Vernon Hills Park District Turtle Creek Water Park

ADDENDUM 1

Re: Addendum #1 for Turtle Creek Water Park

Below are written descriptions of revisions and clarifications for the Civil Engineering Documents prepared for the Turtle Creek Water Park project in Vernon Hills, Illinois.

C-3.3
SITE DEVELOPMENT
DETAILS

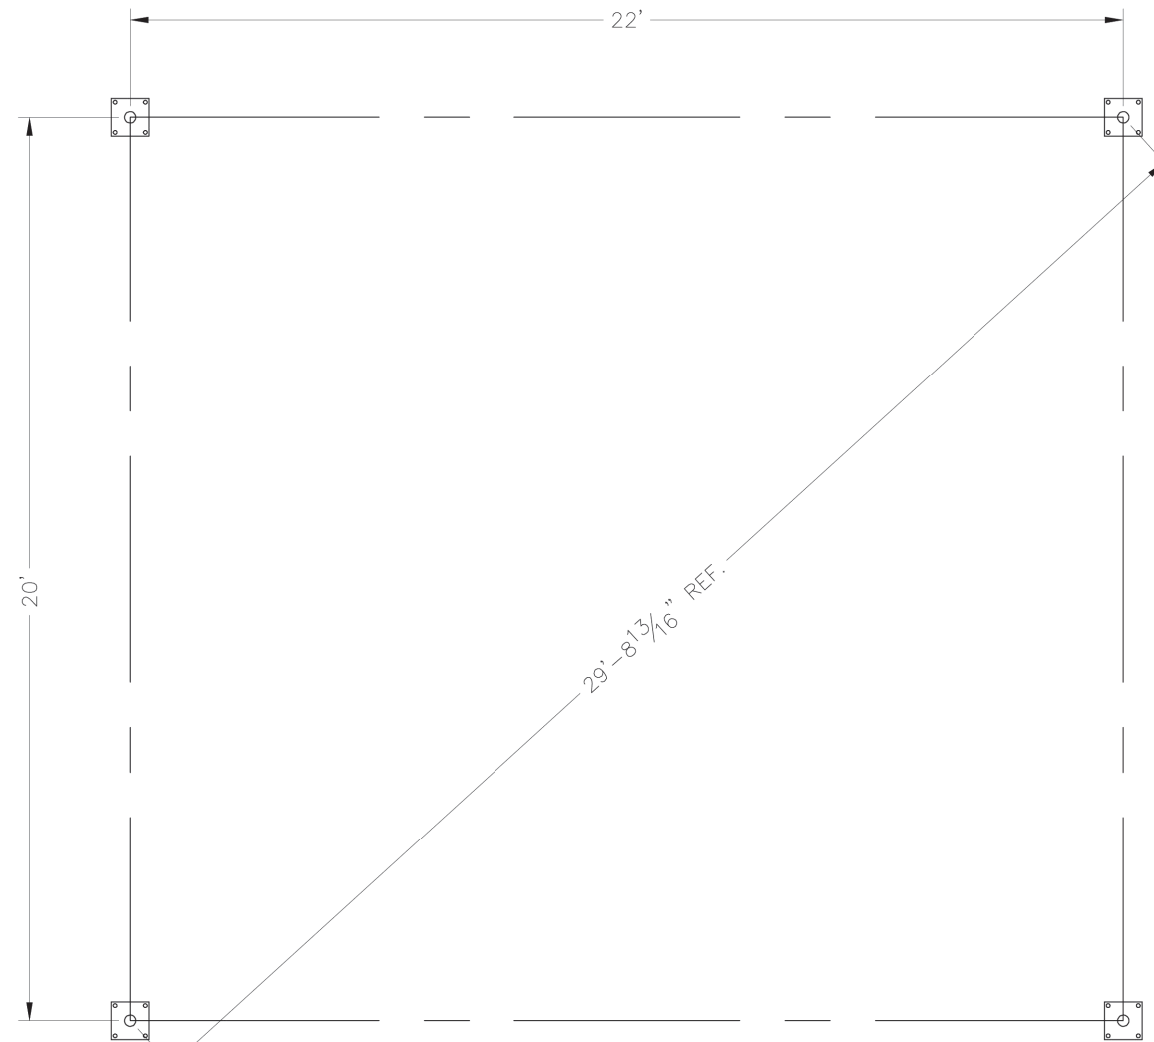
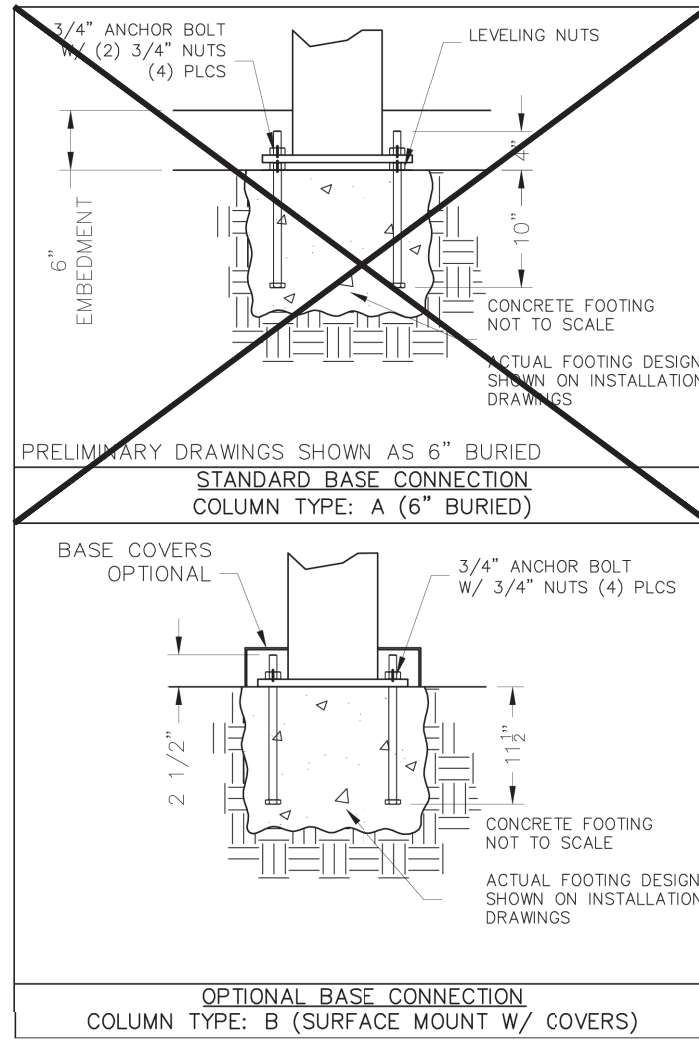
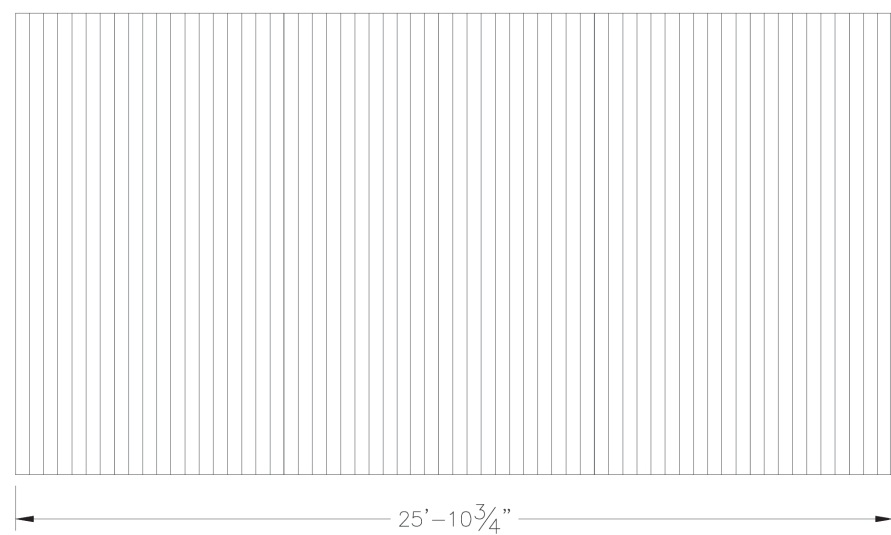
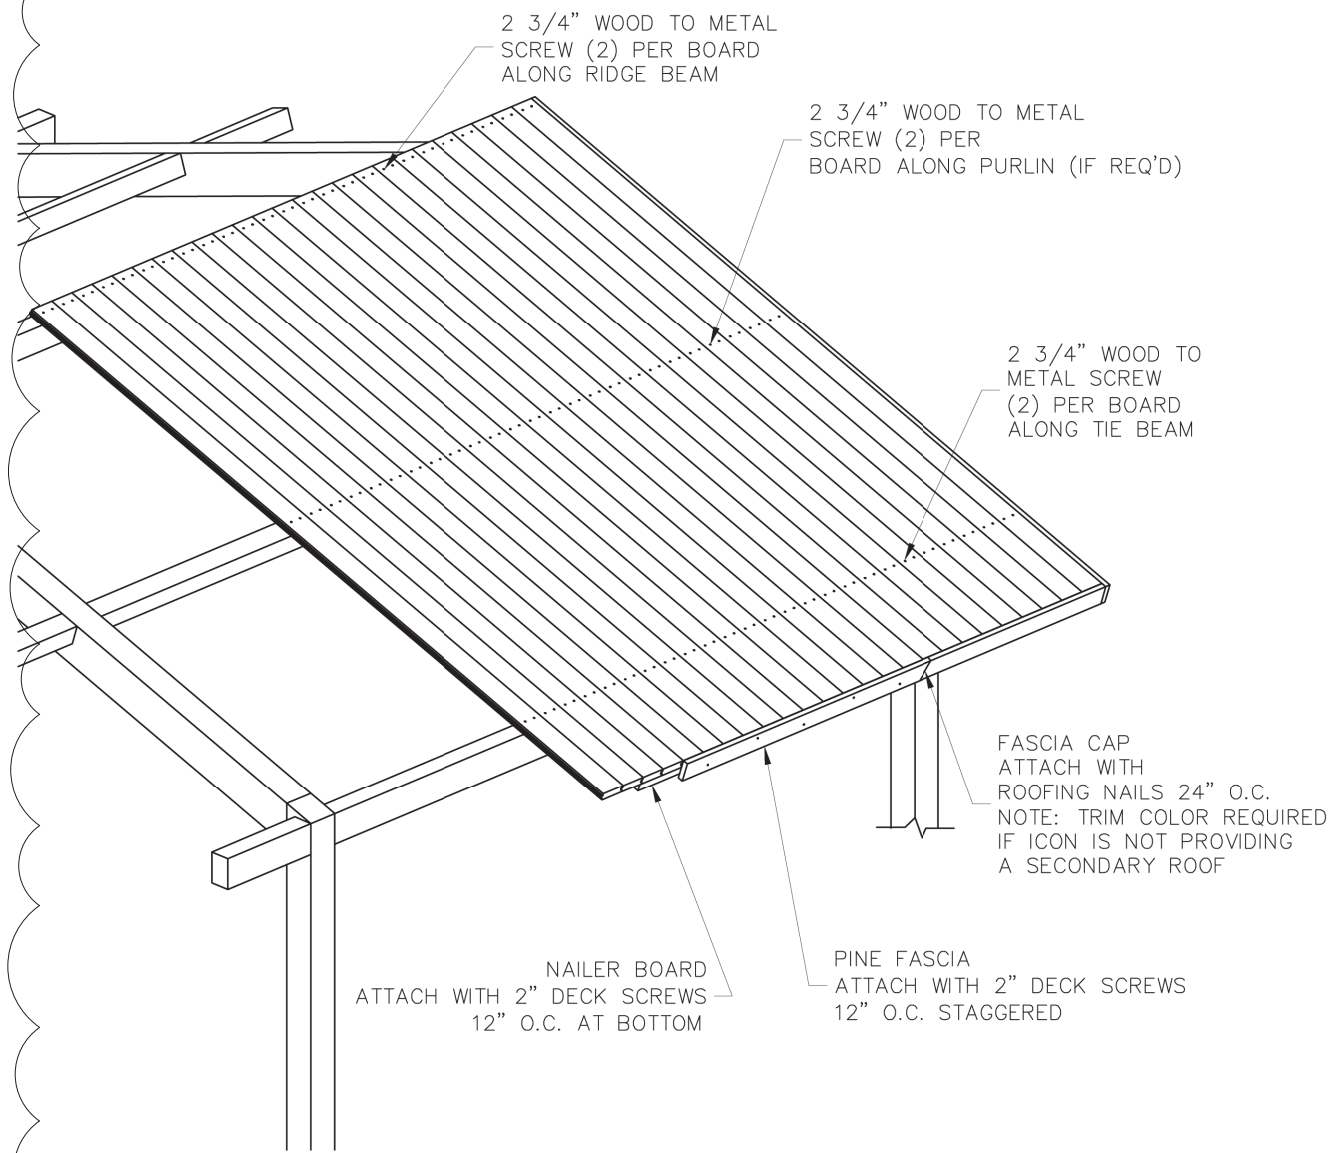
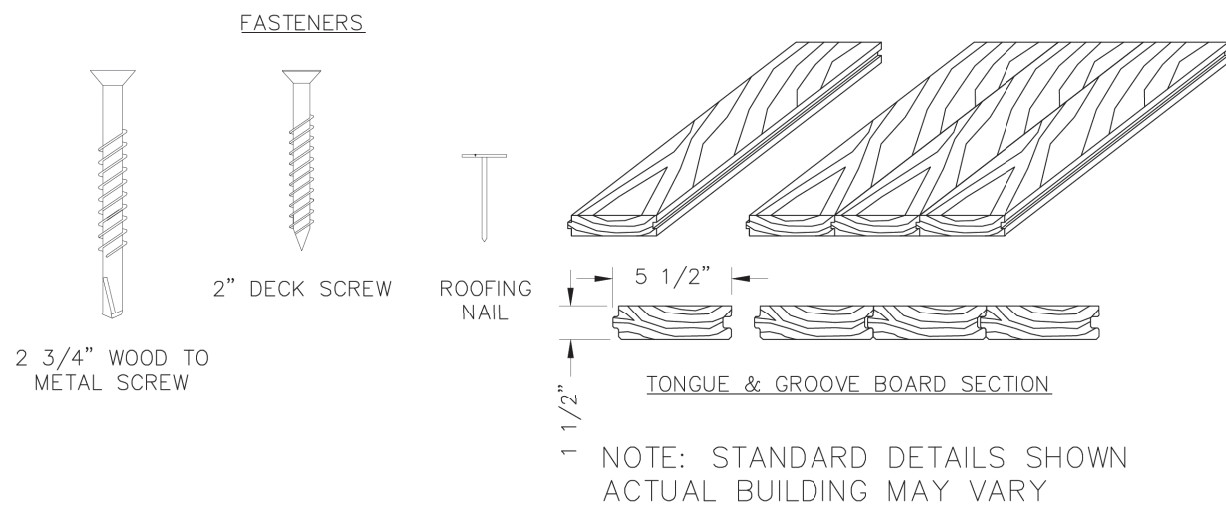
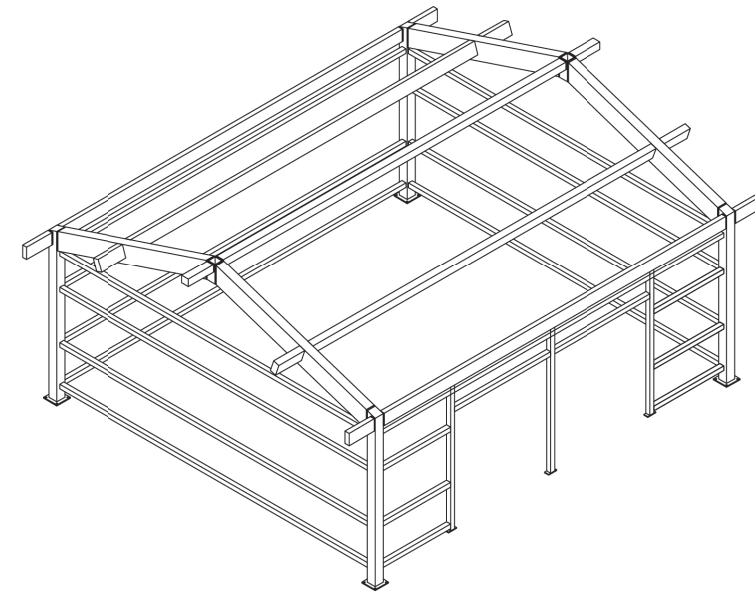
1. Replaced equipment enclosure details with the most current version received from ICON.

C-5.0
SITE UTILITY PLAN

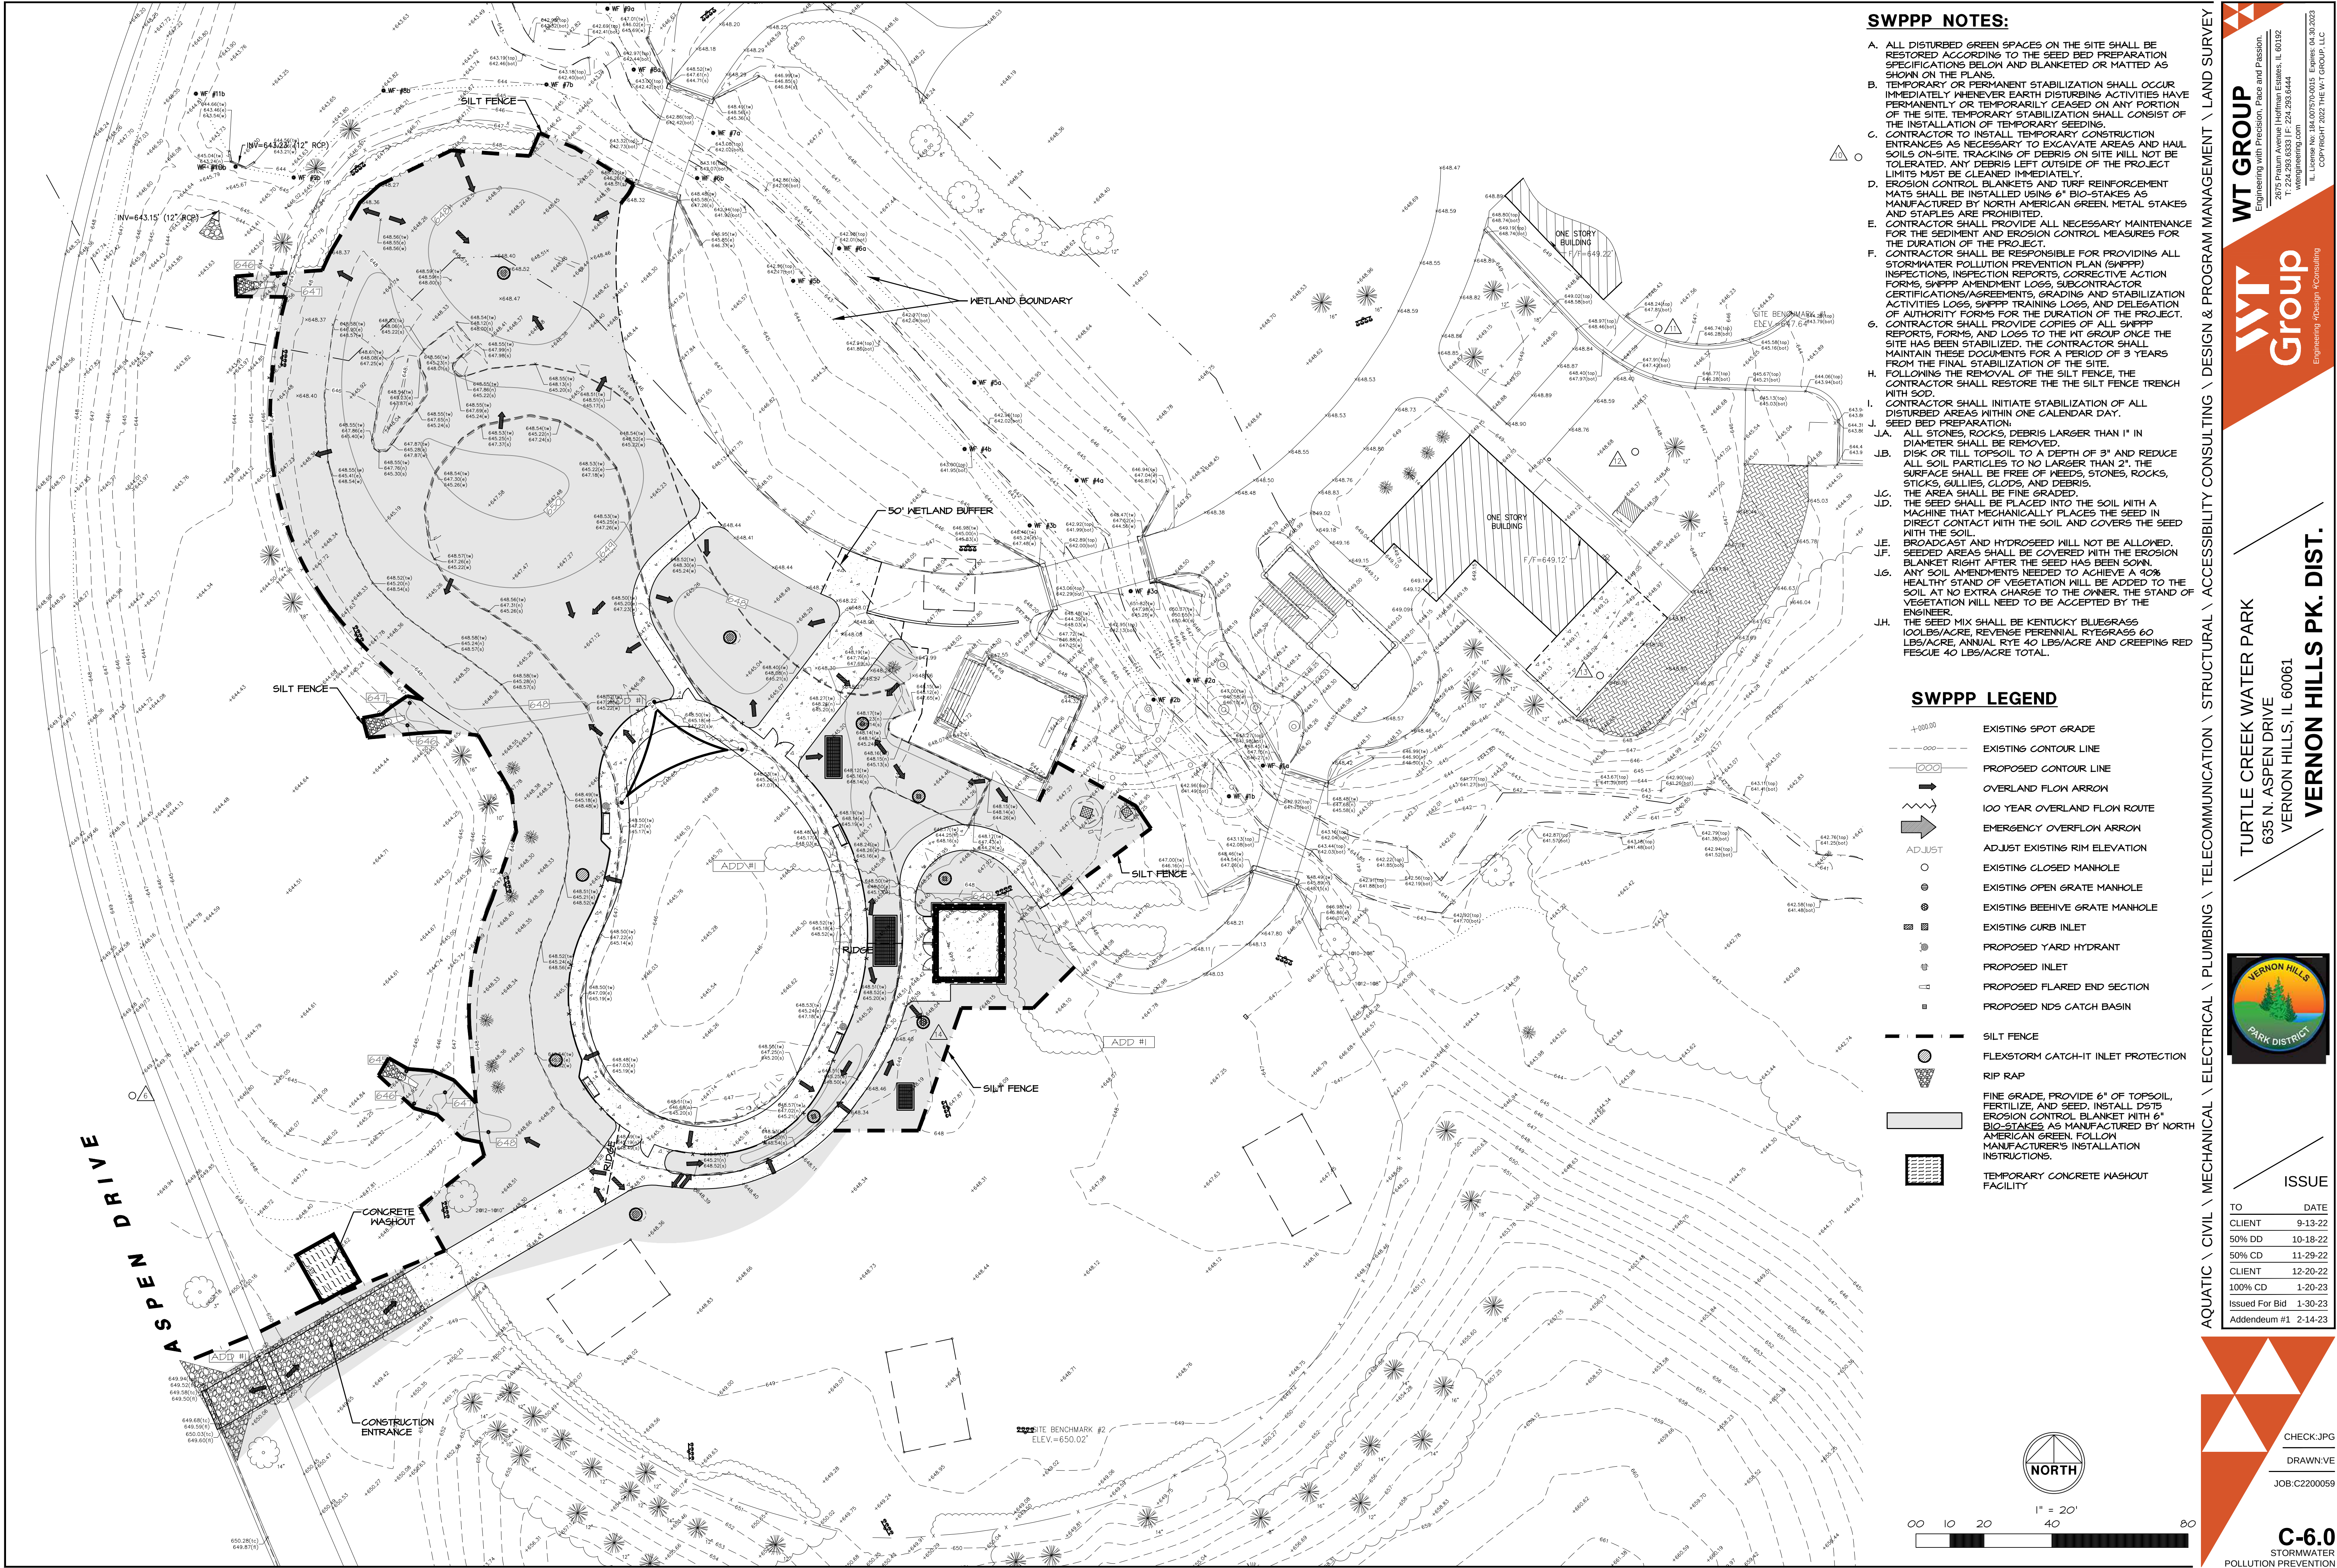
1. Replaced section of existing sidewalk near Aspen Drive at crossing with the existing grass pavers.
2. Adjusted location of the proposed shade structure to avoid conflicts between the foundations and the proposed splash pad.
